Access Compliance Report

Public Rights-of-Way

Intersection ID: 3438	Main Street: TREYBURN_DR	Cross Street: W_W_T_HARRIS_BV	Location: SW
ADA ID: 924D117815B0	Ramp Type: BlendTrans2	Initial Pass/Fail: Fail	Overall Compliance: No
		Severity Score: 10

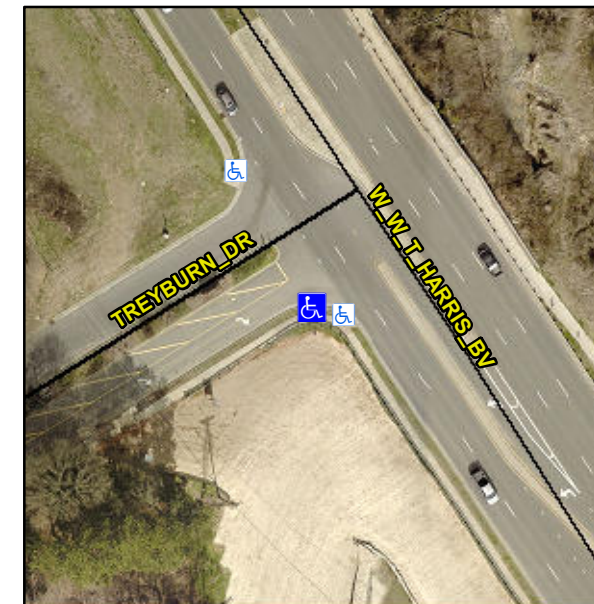
Not Found, R304.5.1, R304.5.3

Compliance	Description	Data	Compliance	Description	Data
N/A	Ramp Length (in)	89.0	Yes	BlendTrans Slope (%)	3.1
No	Ramp Width (in)	47.0	No	BlendTrans XSlope (%)	2.6
N/A	Flare Type LT	N/A	N/A	Flare Type RT	N/A
N/A	Flare Slope LT (%)	N/A	N/A	Flare Slope RT (%)	N/A
N/A	Flare Traversable LT?	N/A	N/A	Flare Traversable RT?	N/A
N/A	Landing Length (in)	N/A	N/A	DWS Provided?	N/A
N/A	Landing Width (in)	N/A	N/A	DWS Contrast?	N/A
N/A	Landing Slope (%)	N/A	N/A	DWS Length (in)	N/A
N/A	Landing X Slope (%)	N/A	N/A	DWS Full Width?	N/A
N/A	Landing Curb? (Y/N)	N/A	N/A	DWS Offset (in)	N/A
N/A	Shared Landing?	N/A			
N/A	Gutter Ponding?	N/A	N/A	Gutter Slope (%)	N/A
N/A	Gutter Lip Ht (in)	N/A	N/A	Gutter X Slope (%)	N/A
N/A	Painted X Walk1?	No	N/A	Painted X Walk2?	N/A
	X Walk 1 Direction	To N		X Walk 2 Direction	N/A
	X Walk 1 Width (in)	N/A		X Walk 2 Width (in)	N/A
	X Walk 1 Slope (%)	3.1		X Walk 2 Slope (%)	N/A
	X Walk 1 X Slope (%)	3.6		X Walk 2 X Slope (%)	N/A

N/A	Ramp inside XWalk1?	N/A	N/A	Ramp inside XWalk2?	N/A
	Road Slope (%)	3.6		Clear Space?	N/A
	Road X Slope (%)	3.1	N/A	Clear Space to XWalk (in)	N/A
N/A	Any Obstructions?	N/A	N/A	Storm Grate/Utility Hazard?	N/A
	Obstruction Type			Storm Grate/Utility Type	
		N/A			N/A
			Yes	Surface Condition? (G/P)	Good
			No	Curb Slope (%)	7.9

Remove & Replace Curb Ramp With Two New Directional Ramps or Equivalent.
